SERVICE BULLETIN

SERVICE BULLETIN INDEX

FIGURE 1
COMPRESSOR OUTLET DUCT COUPLING INSTALLATION

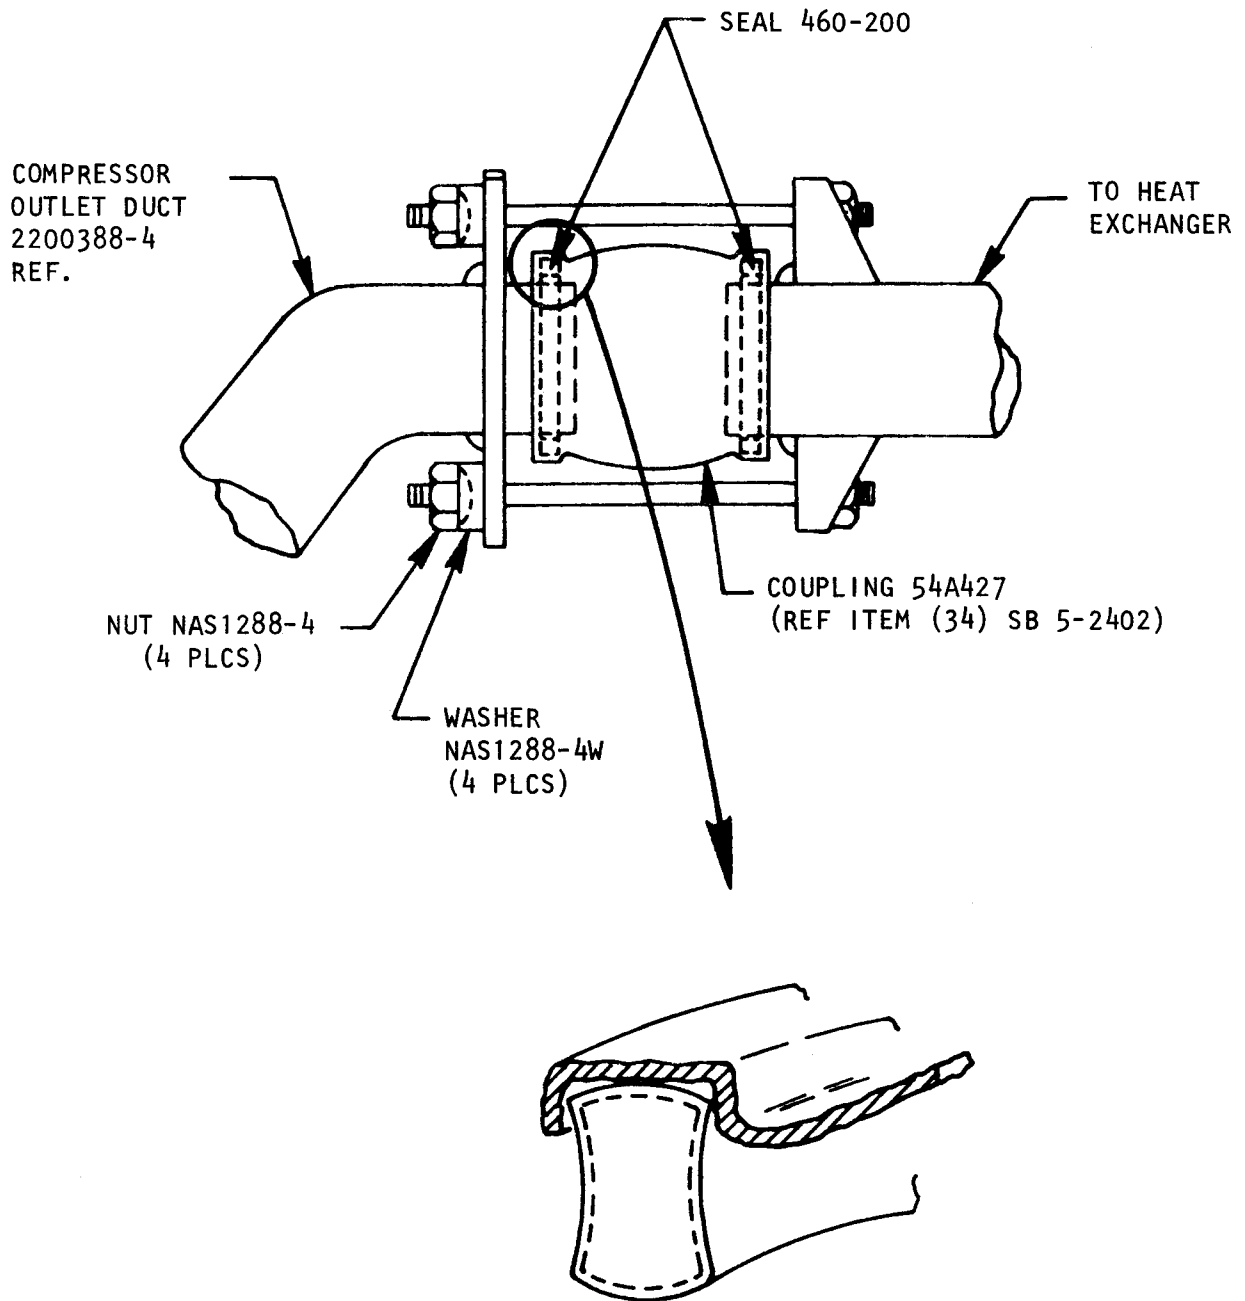
**See Figure 1 for seal installation.

Aircraft Refrigeration Unit
Part No. 2200165-2 and 2200165-3
Figure 1

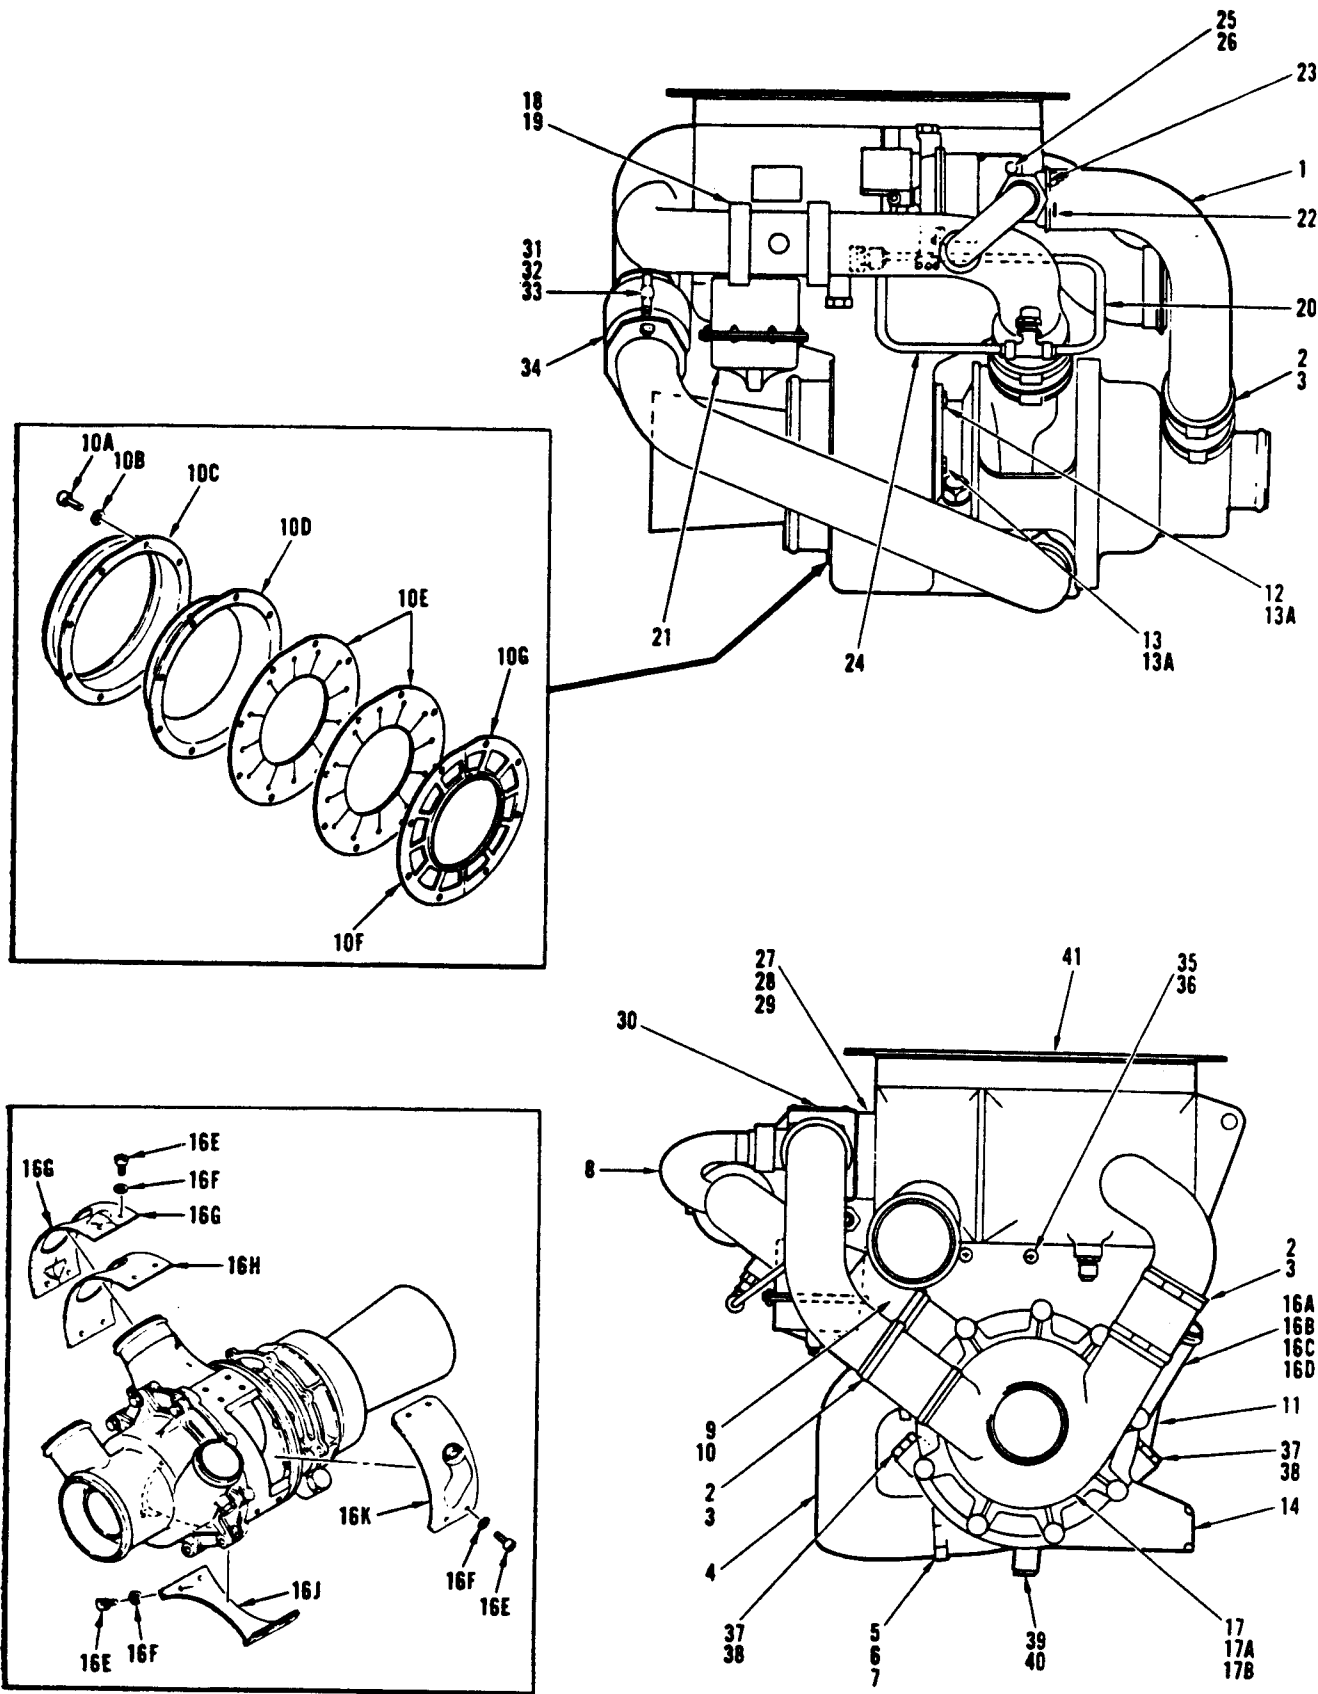
- (1) Remove 2200392-1 Regulating Valve Supply Pressure Tube Assembly (20, figure 1).
- (2) Remove 2200388-1 Compressor Outlet Duct Assembly (4) by removing three screws (5), nine washers (6), one packing (7), four nuts (31), four washers (32), two studs (33), and coupling (34) as shown in figure 1. Retain attaching hardware.

- (4) Remove 898730-1 Fluid Pressure Regulating Valve (21, figure 1) by removing two clamps (18) and two packings (19) as shown in figure 1. Retain attaching hardware

- (3) Install new 2200388-4 Compressor Outlet Duct Assembly (4A, figure 2) and secure with three screws (5), nine washers (6), one packing (7), four nuts (31), four washers (32), two studs (33), and coupling (34) as shown in figure 2.

- (5) Install new 898730-3 Fluid Pressure Regulating Valve as shown in (21A, figure 2) and secure with two packings (19) and two clamps (18) as shown in figure 2.

FIGURE 1 PILOT AND CO-PILOT CONTROL WHEEL SWITCH MODIFICATION

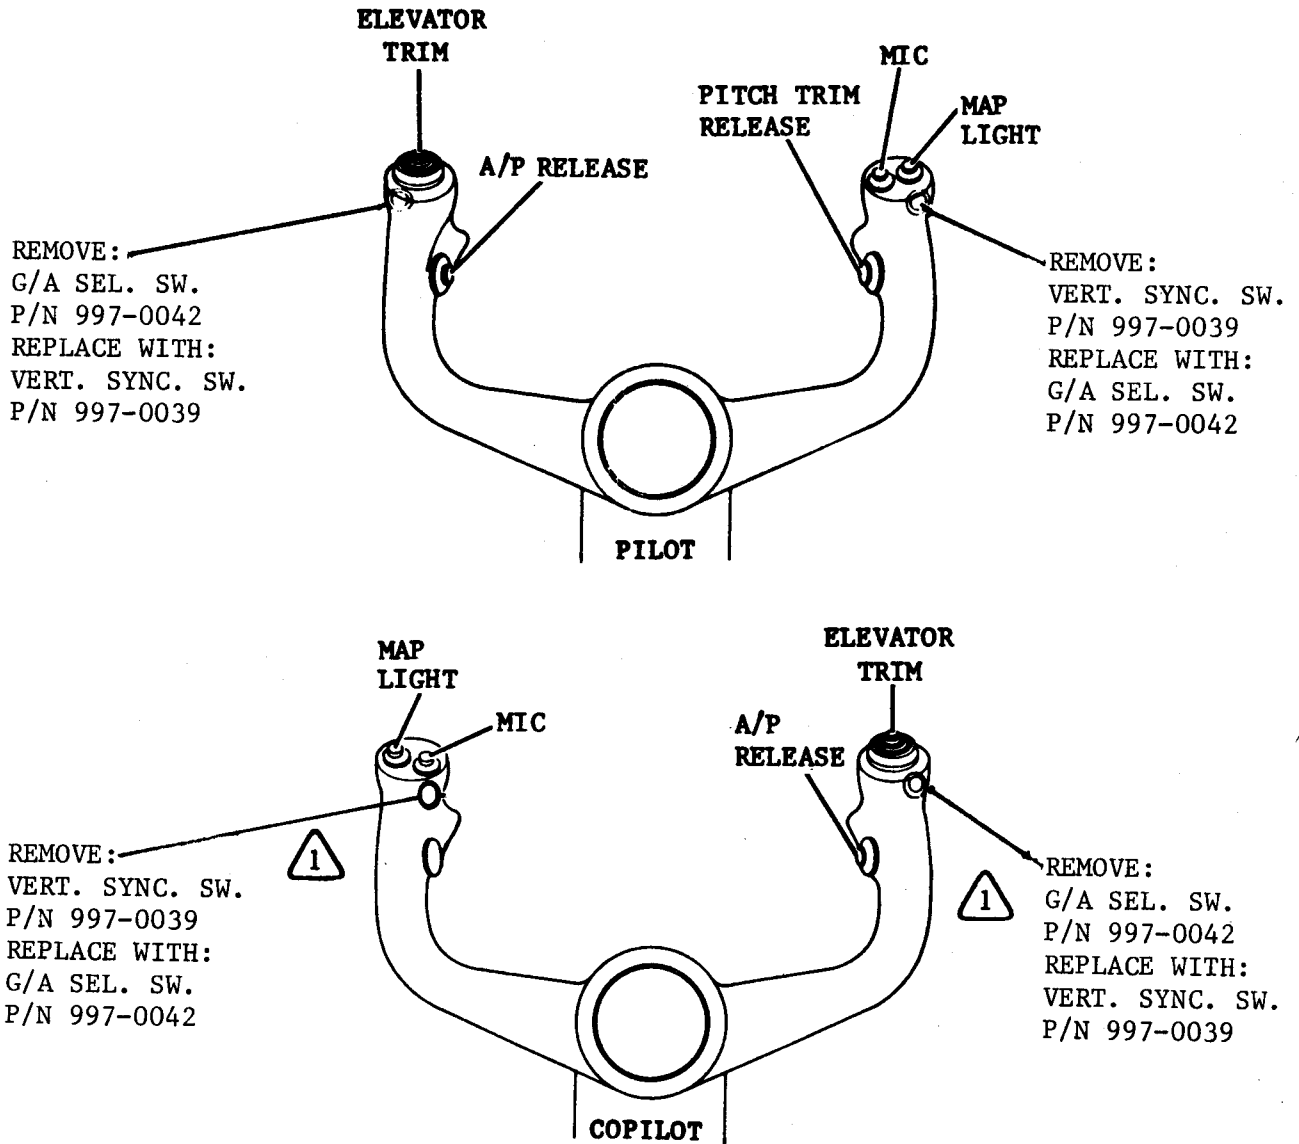
- A. Turn off battery and electric master switches and assure external power is disconnected.
- B. Locate and mark wiring to G/A and Vertical Sync switches.
- C. Remove G/A and Vertical Sync switches from pilot and co-pilot control wheels. Reference Figure 1.
- D. Disconnect wiring from switches and pull out of yokes. Reference Figure 2.
- E. Re-feed wiring to opposite side of each yoke and re-attach to switches that have been moved to opposite sides of yoke.
- F. Re-install switches in yokes and re-secure wiring as required.
- G. Check out switches for operation and return aircraft to service.

FIGURE 1

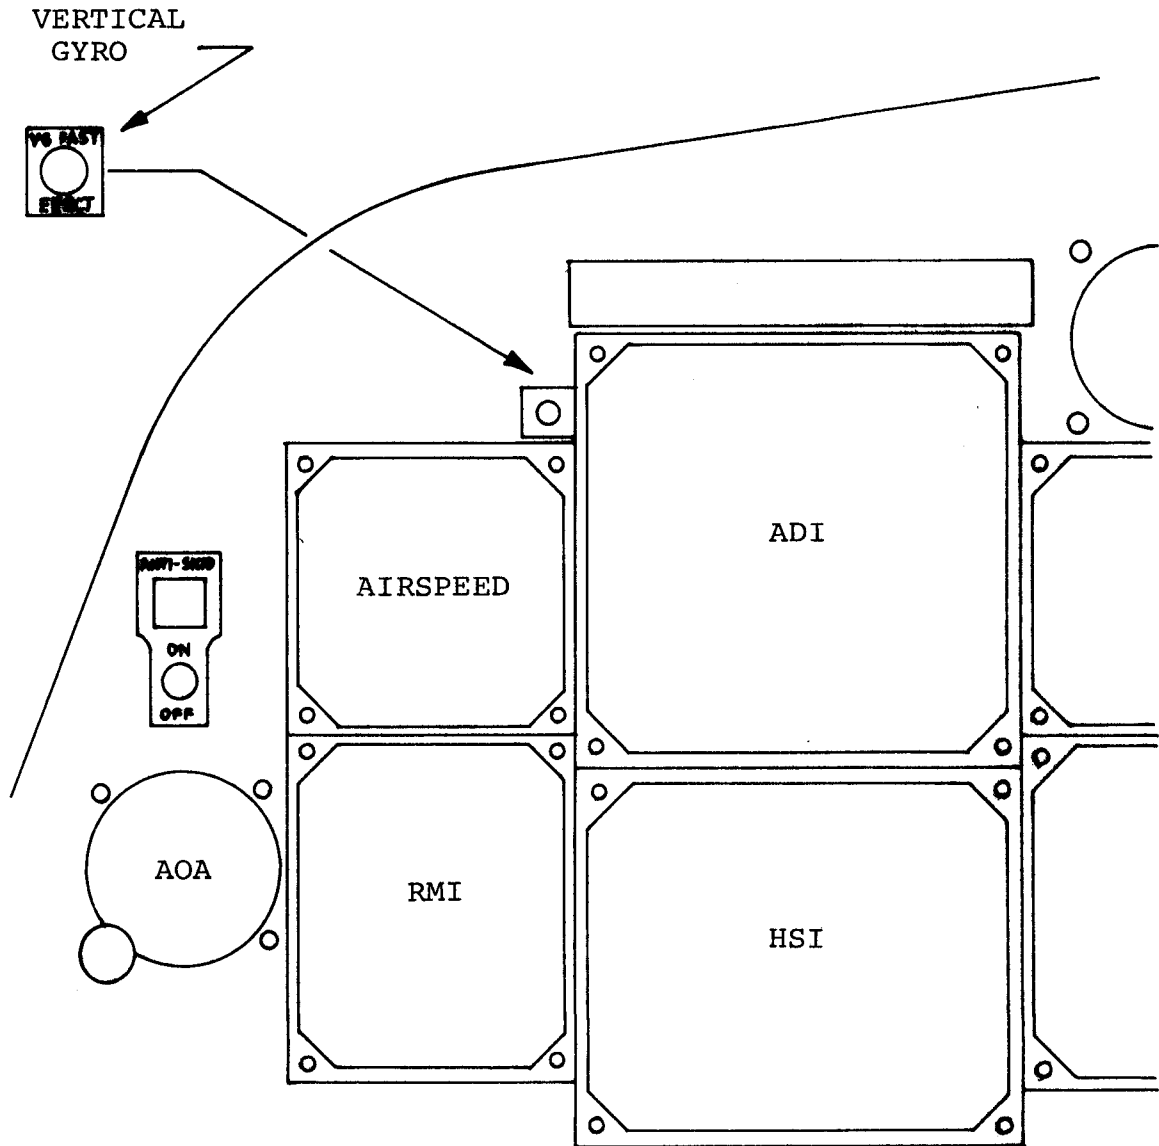
- (4) Locate vertical gyro fast erect switch on pilots instrument panel as shown in Figure 1, using standard shop practices. (Switch installation on copilot's panel is typical for aircraft with dual vertical gyro installations).

FIGURE 2

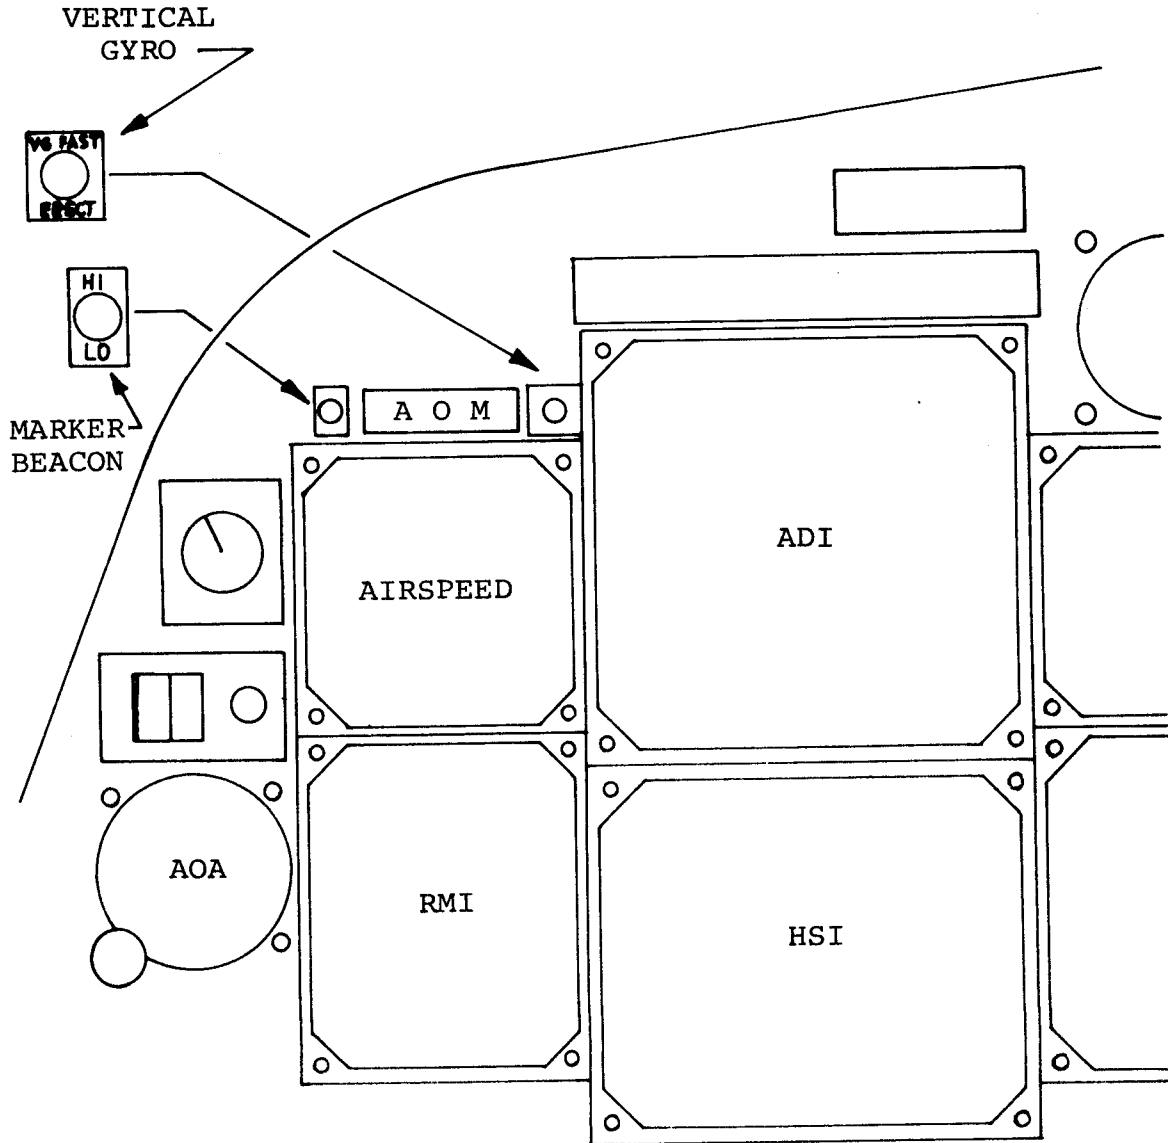
- (4) Locate vertical gyro fast erect switch on pilot's instrument panel as shown in Figure 1 or 2, using standard shop practices, (Switch installation on copilot's panel is typical for aircraft with dual vertical gyro installations).

FIGURE 1

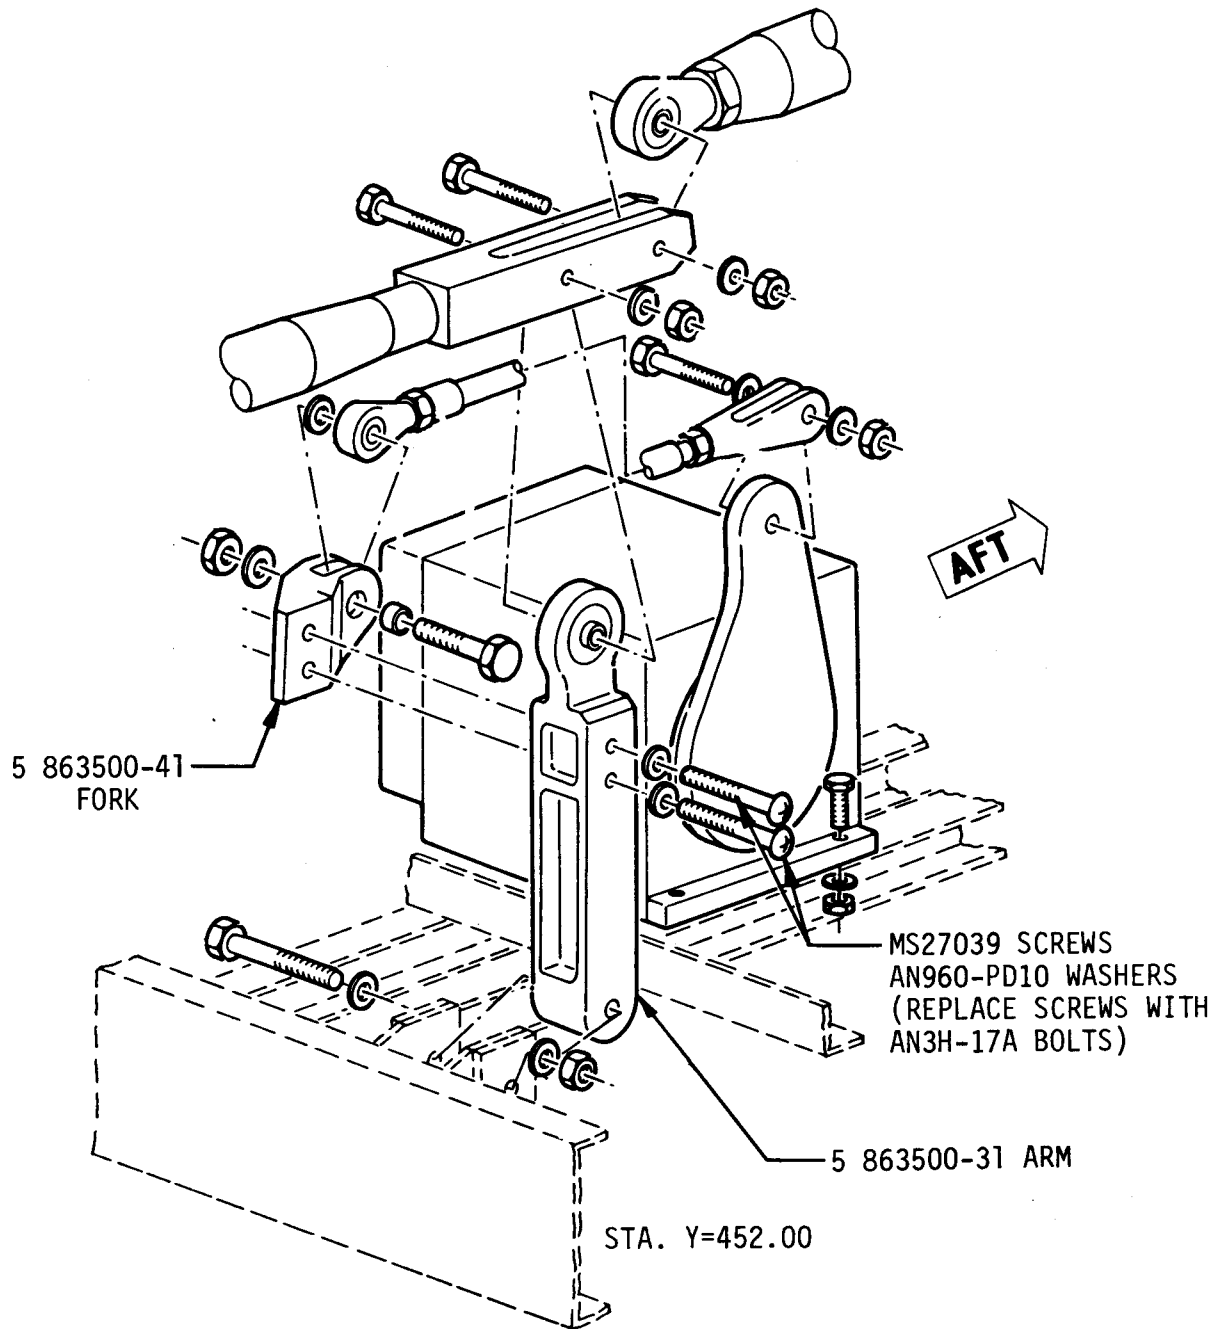
- A. Remove overhead access panels in aft baggage compartment as necessary to gain access to P/N 863500-31 arm and 863500-41 fork, ref. Fig. 1.
- B. Remove 2 each MS27039 screws and 2 each AN960-PD10 washers, discard screws and retain washers.
- C. Install 2 each AN3H-17A bolts with AN960-PD10 washers under heads. Torque to 20-25 inch-pounds and safety wire.
